DESIGN <i>PH</i>	DRAWN BY <i>PH</i>	DART AEROSPACE LTD HAWKESBURY, ONTARIO, CANADA	
CHECKED <i>#</i>	APPROVED <i>#</i>	DRAWING NO. DSI 9297	REV. A SHEET 1 OF 1
DATE 05.03.15	TITLE CROSSTUBE MODIFICATION KIT		SCALE NTS
A	05.03.15	NEW ISSUE

DART SERVICE INSTRUCTION

TO AMEND INSTALLATION INSTRUCTIONS IIN-D212-664 REV. B

FIGURE 1

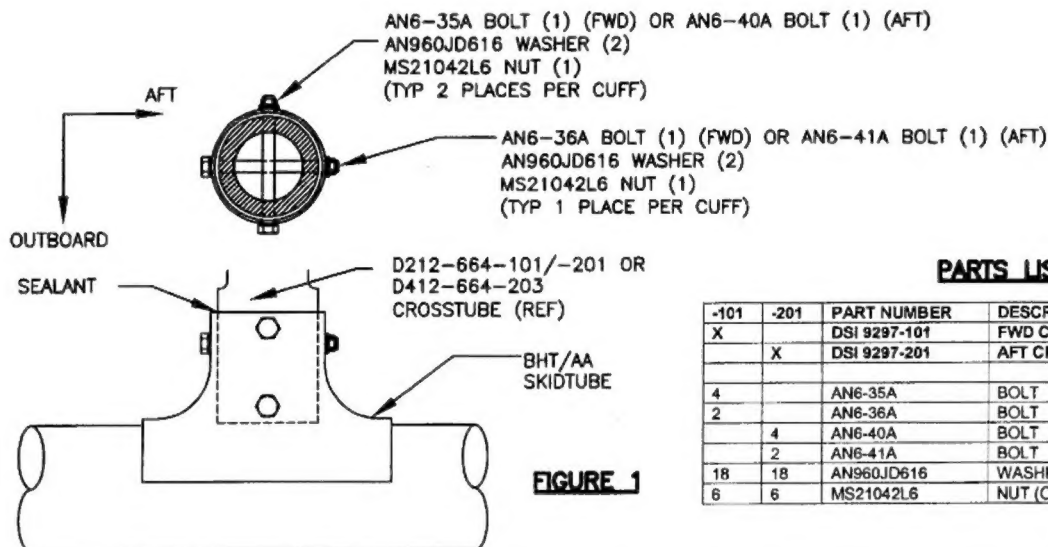
- 6) INSERT CROSSTUBE(S) INTO SKIDTUBE SADDLE(S). ENSURE SADDLE AND CROSSTUBE HOLES
ARE ALIGNED. ATTACH THE CROSSTUBE TO THE SKIDTUBE SADDLE USING 4 AN6-35A/-40A BOLTS
AND 2 AN6-36A/-41A BOLTS AS SHOWN IN FIGURE 1. ENSURE ALL BOLTS ARE FACING INBOARD
OR AFT. ENSURE BOLT THREADS ARE NOT BEARING ON SADDLE SHEET. EXTRA AN960JD616
WASHERS MAY BE REQUIRED UNDER THE NUT TO ENSURE NUT DOES NOT START THREADING BOLT
SHANK. TORQUE NUTS TO 110 IN-LBS.
